ADA Curb Ramp New Construction Inspection Form (Perpendicular)

Nw Kaye

24952.54

Nw Shaddon

PERPENDICULAR RAMP (PR)

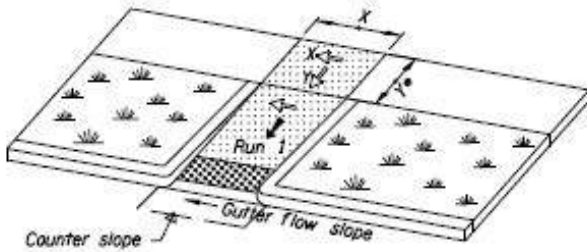
Width X

1.5

≥ 4.0'

< 4.0'

Length Y

1.9

≥ 4.0'*1

< 4.0'*1

RR1 ICRR
